PUBLIC UTILITIES COMMISSION

SUBJECT: Data Request #2 for Presidential Substation Project

Data Request Presidential Substation Project

Visual Simulation Locations

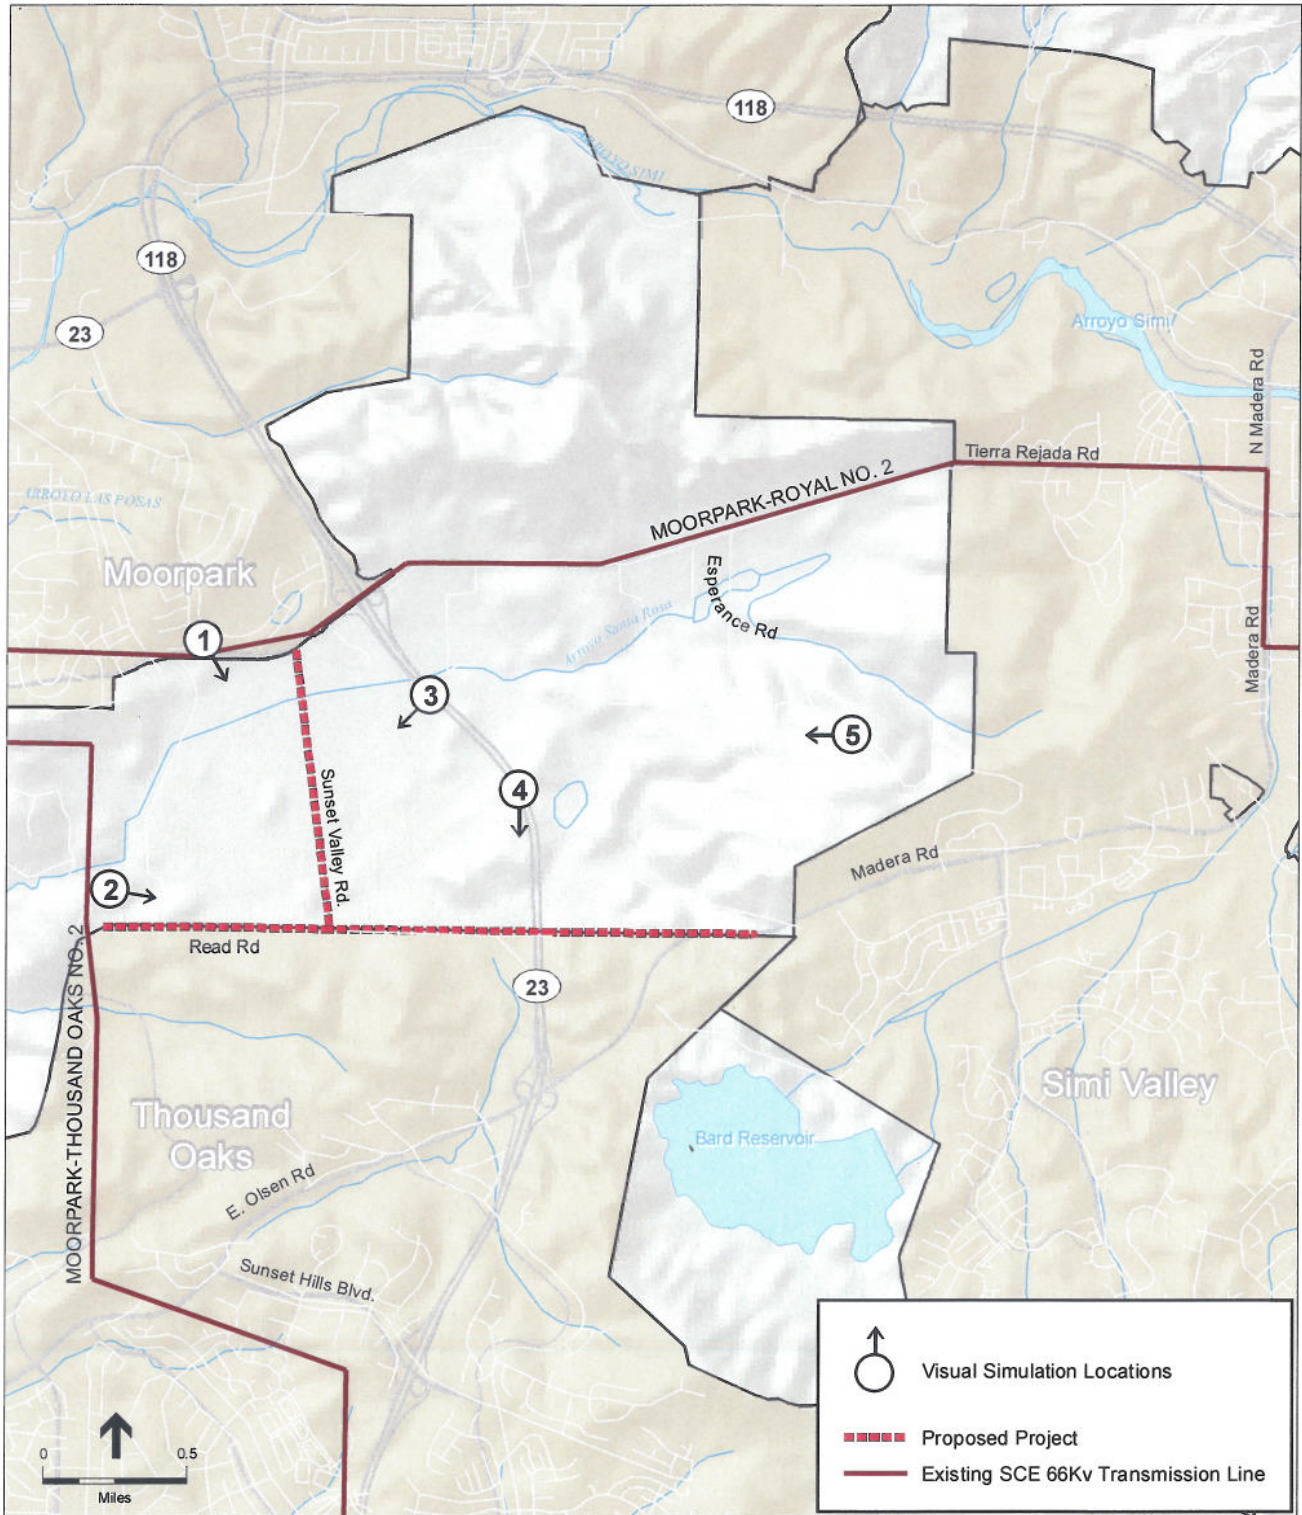
1. Please provide visual simulations of the Proposed Project subtransmission line from the points identified on the attached figure.
 - a. Photo point #1 –represents the intersection with the traffic light.

- b. Photo point #2 – represents the area near the intersection of Moorpark Rd, and Read Road.
 - c. Photo point #3 – represents a photo taken from Hwy 23 showing the Tierra Rejada valley, with the proposed subtransmission line in view.

- d. Photo point #4 – represents the view of where the subtransmission line will cross Hwy 23. The point selected is the point south of the turn where the crossing would come into view.

- e. Photo point #5 – represents the view of the Proposed Project subtransmission line from the Reagan presidential library.
2. Please revise the PEA visual simulation of the Proposed Project substation with the following modifications.
